SERVICE INFORMATION

Bulletin Nbr: 210-2353 Date:.....Maj 2002

Improvement of crankcase ventilation throughflow

Saab 9-5 M98-00 with engine models B205E and B235E.

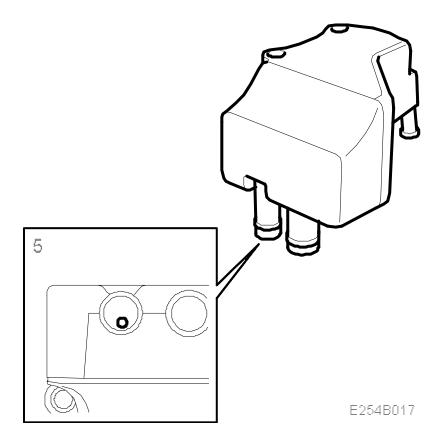
5. Turn the oil trap as shown in the illustration and enlarge the hole for the low-pressure line to 5 mm.

E254B021

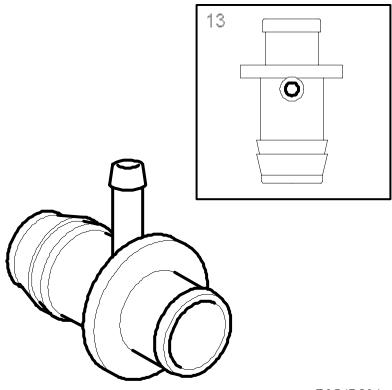
Enlarge the undersized hole to 2.5 mm, remove burrs and blow clean thoroughly.

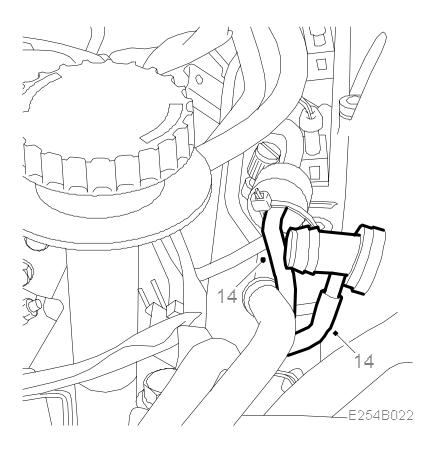
14. Fit the crankcase ventilation nipple with a new rubber bush. Connect the hose with the check valve.
